ADDENDUM No. 1

REQUEST FOR QUOTATIONS No.: 1220-040-2024-034

TITLE: SURREY SPORT AND LEISURE COMPLEX - CHILD MINDING PLAY SPACE AND MULTI-PURPOSE ROOM RENOVATION

ADDENDUM ISSUE DATE: SEPTEMBER 27, 2024

SIDE VIEW
MODELS WITH HORN (STI-1100 Series)

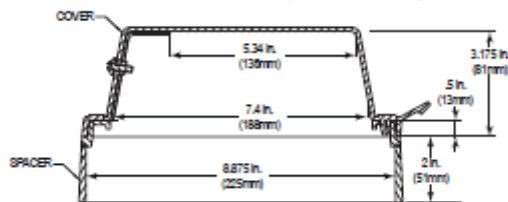
Q42. Fire alarm devices are not available in a “Child proof” or “Shatter proof” model, so additional covers/protection may be required. Please confirm the specification for the protective cover.

- a. For note C – allow a STI 1100 protective cover over manual pull stations.

A42. Refer to ATTACHMENT NO. 1 – FIRE ALARM COVER for specification.
